SUBJECT: Submits explanation of failure of emergency svc water sys &  
 discussion of impact on plant performance. During recent  
 design activities associated w/mod, unidentified &  
 unevaluated single failure discovered in sys.

SUSQUEHANNA STEAM ELECTRIC STATION  
ADDITIONAL INFORMATION - ESW SYSTEM  
ER 100450 FILE 841-2  
PLA-1388

Docket No. 50-387

FIGURE 1

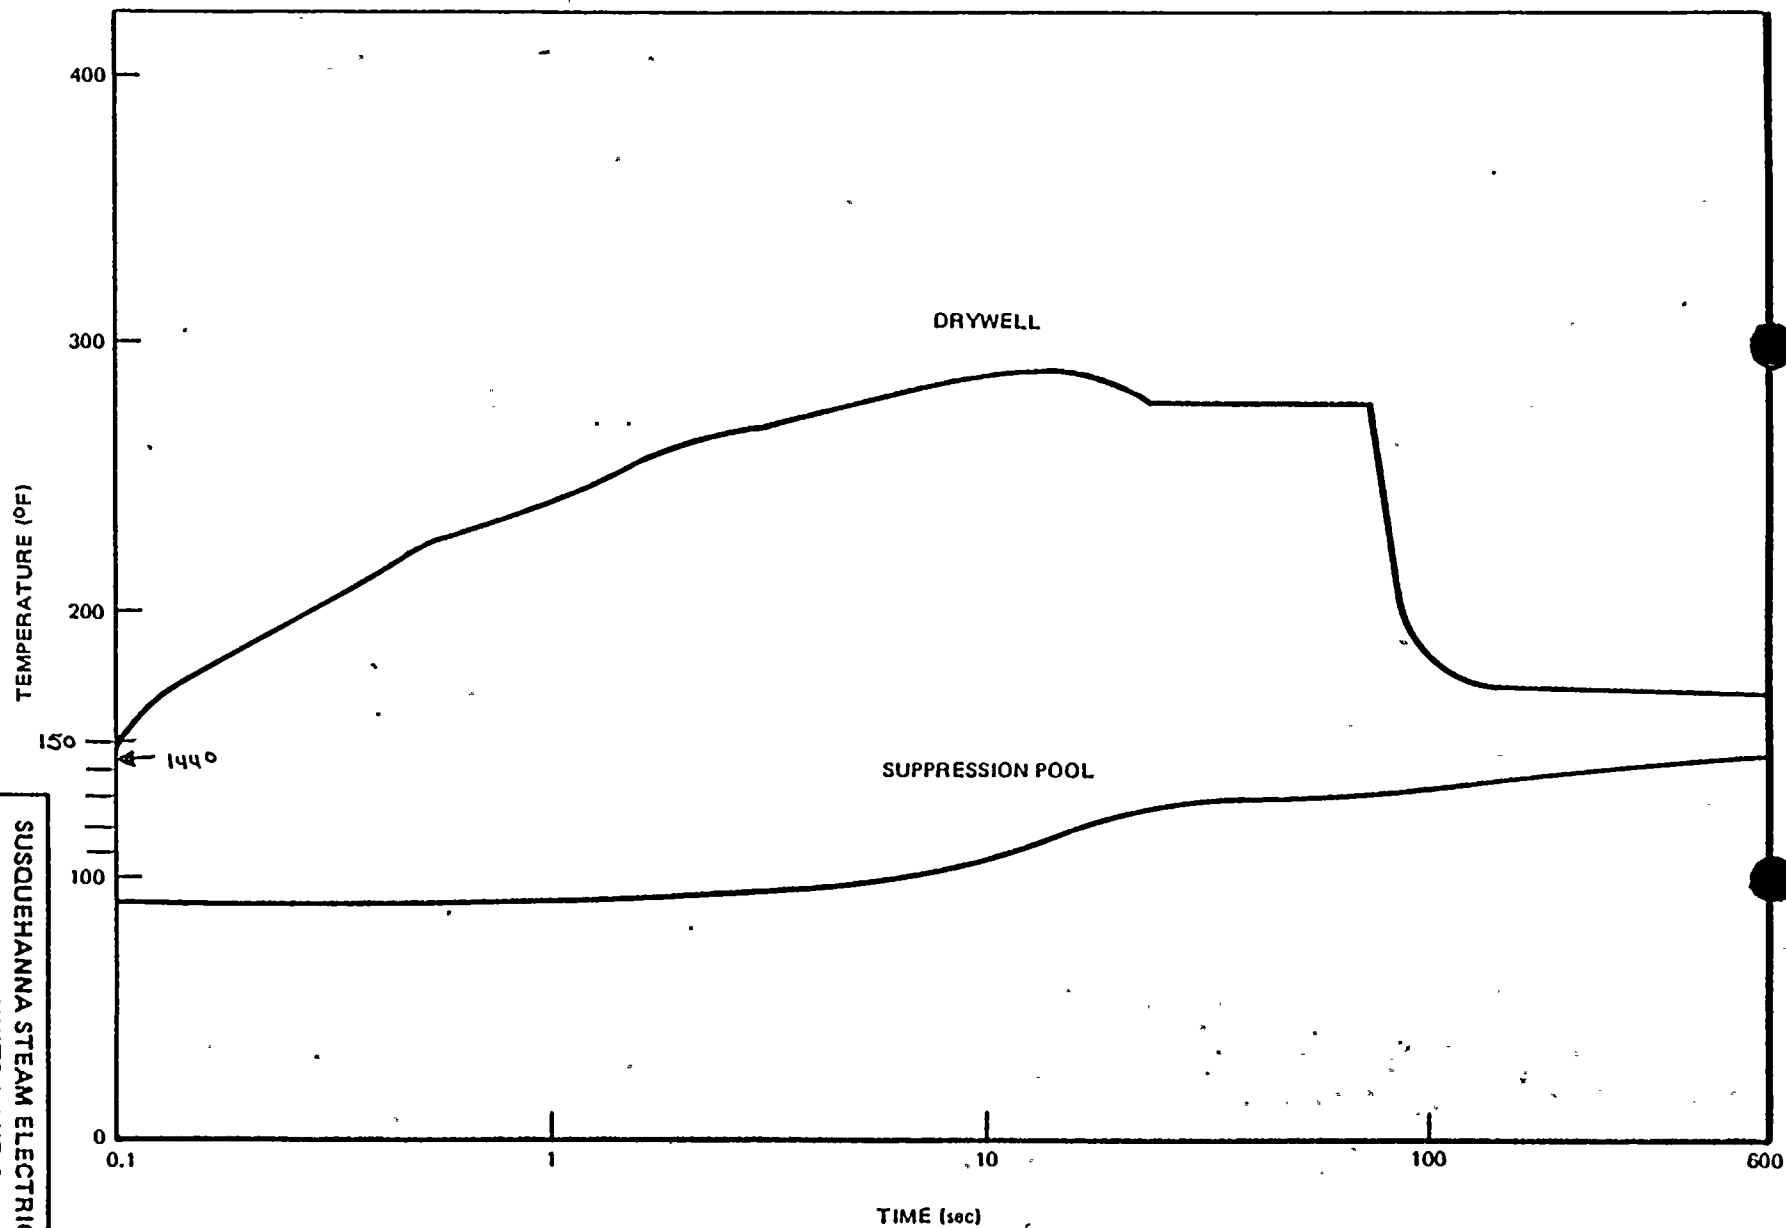
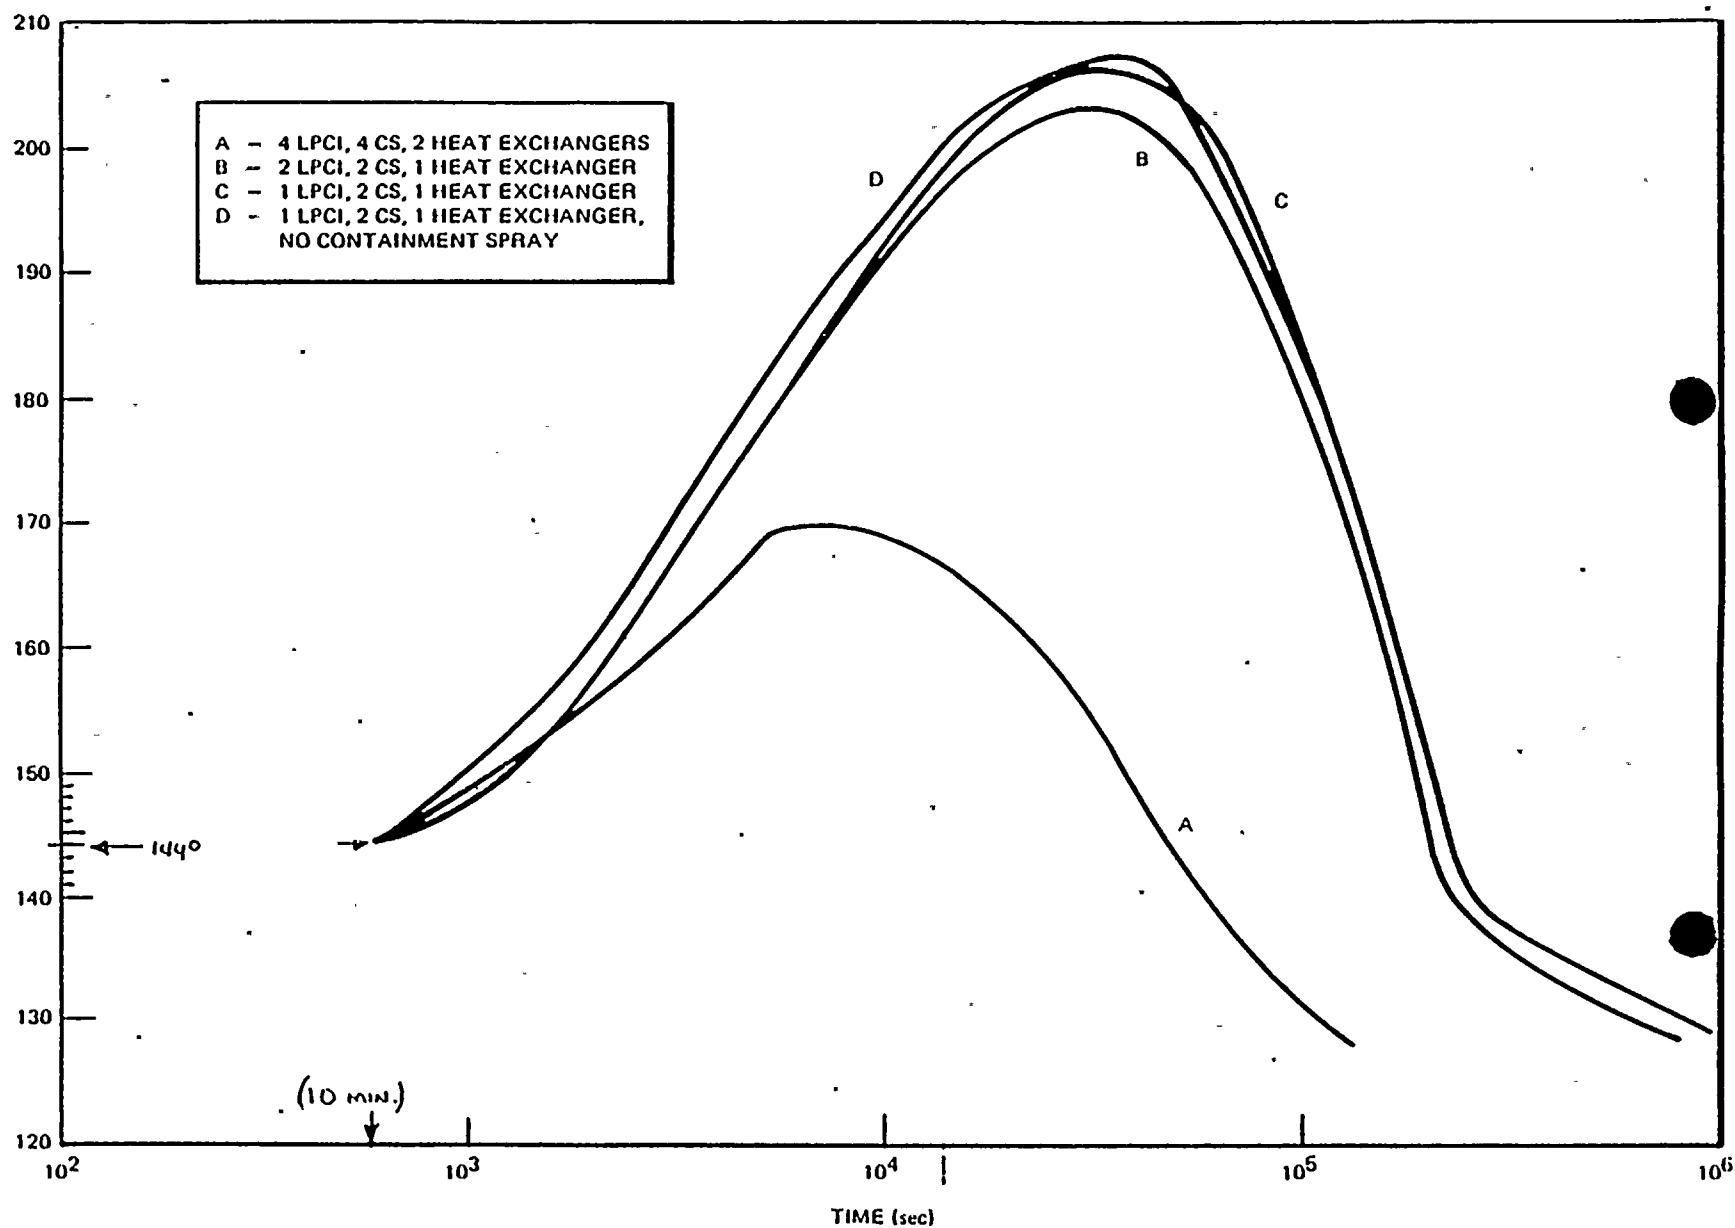
The only heat source for which the test conditions did not closely approximate the postulated accident conditions was the Suppression Pool. During the test the Suppression Pool temperature was at ambient conditions. Figures 1 and 2 show that the expected temperature variation could be an increase of 54° from the upper Technical Specification limit of 90°F to 144°F as shown. Justification for this correlation is contained under "Conclusions" of this report.

FIGURE 3

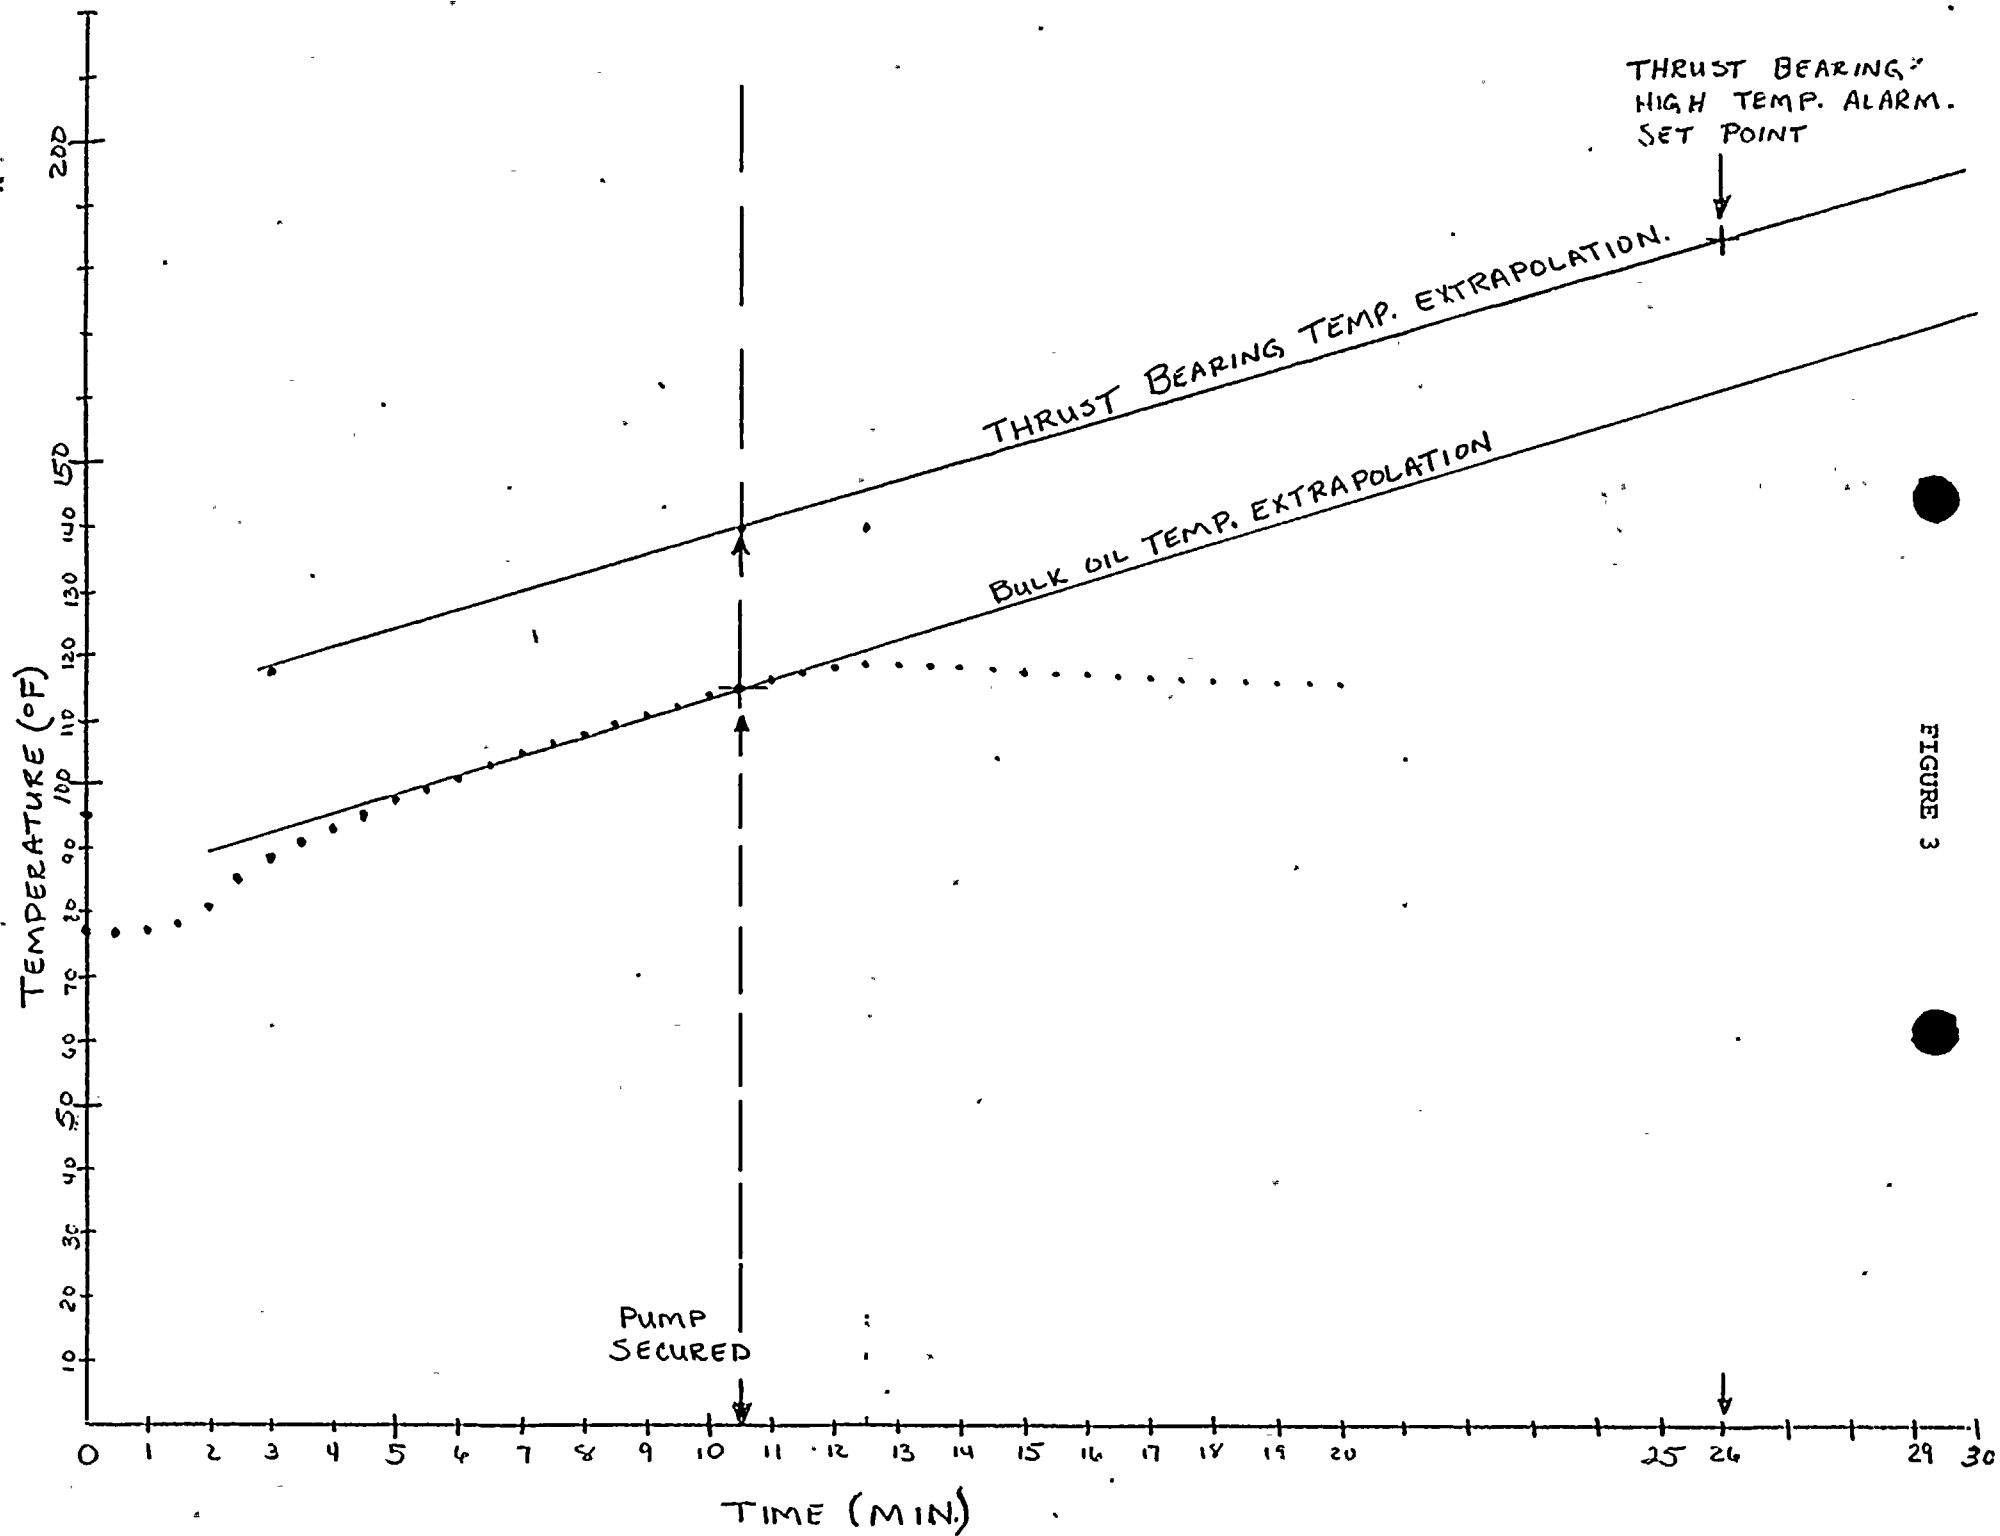
The highest internal pump temperature recorded was 140.0°F at T=10.5 minutes on the Kingsbury thrust bearings, while the highest bulk oil temperature was 118.4°F at T=12.5 minutes, 2 minutes after the pump was secured. Figure 3 is a graph showing the bulk oil temperature plotted every 30 seconds for a period of 20 minutes with an extrapolation showing the potential temperature increase had the pump not been secured at T=10.5 minutes. The thrust bearing temperature is also shown extrapolated to the high temperature alarm point of 185°F. This extrapolation implies that the pump can be run for approximately 26 minutes before exceeding the manufacturer's recommended alarm point on any bearing surface. The maximum temperatures recorded on the upper and lower guide bearings were 95°F and 110°F, respectively. As expected, the thrust bearing temperature was the limiting condition. During the test the following parameters remained constant:

# ESW AS IT PRESENTLY EXISTS

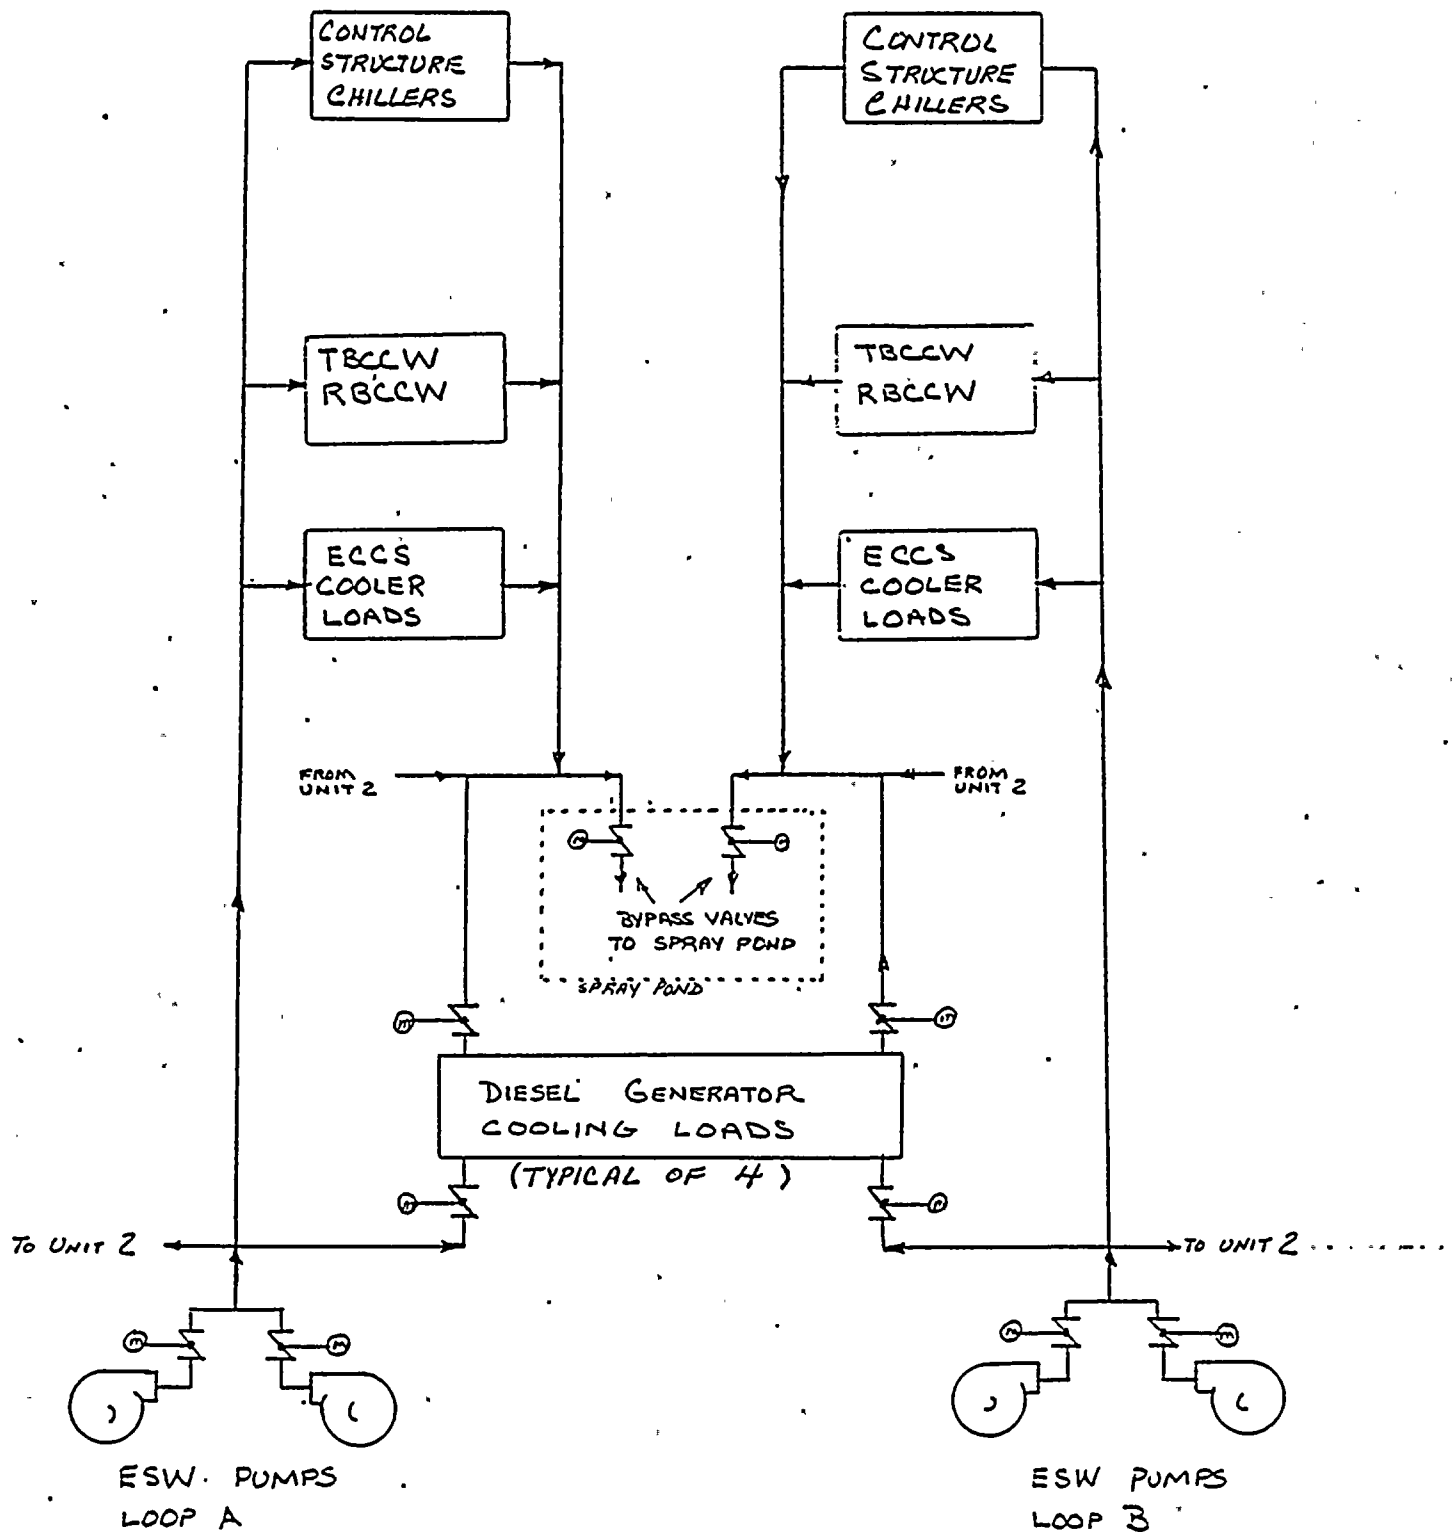
During recent design activities associated with a modification at Susquehanna Steam Electric Station, it was discovered that an unidentified and unevaluated single failure potential exists in the Emergency Service System (ESW). This system supplies cooling water for on site emergency A.C. power Diesel Generators (DG's), for the Control Structure HVAC chiller, and to ECCS equipment and room coolers. The single failure could result in degradation of these systems' performance.

Upon investigation it was found that this failure, ie. the ESW loop bypass valve failing to open when the system is initiated, was missed in the failure mode and effects analysis (FMEA) because the analysts assumed the valve to be normally open and not subject to failure on system initiation. The system operation as originally planned in the early 1970's included a normally open position for this valve but the line-up was changed in late 1977 to prevent the system from draining while shutdown, thus reducing the potential for water hammer. This change was not properly factored into the FMEA performed later (1981).
